Metropolitan Planning Commission

Staff Reports
REVISED

March 24, 2011

Existing Elevation 'E'
 500-02002

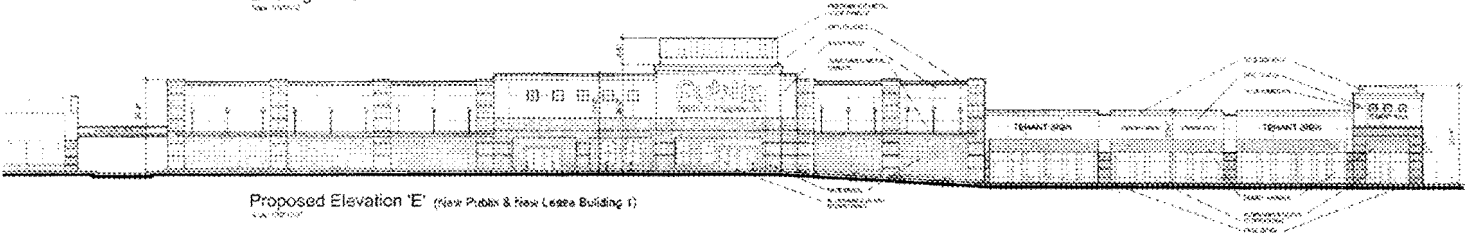
1. The area of the primary individual building sign for the building identified as Publix shall not be limited to 64 square feet. The primary sign, as indicated on the submitted elevation, may contain up to 5 percent of the façade area, 208 square feet, based upon the current planned building. Secondary signs for this building shall be limited to 64 square feet.
2. The area of the primary individual building signs for anchor tenant spaces, with lease areas greater than 12,000 square feet. and facades taller than 26 feet shall not be limited to 64 square feet. Individual sign areas for the spaces may contain up to 84 square feet. Secondary signs for this building shall be limited to 64 square feet.
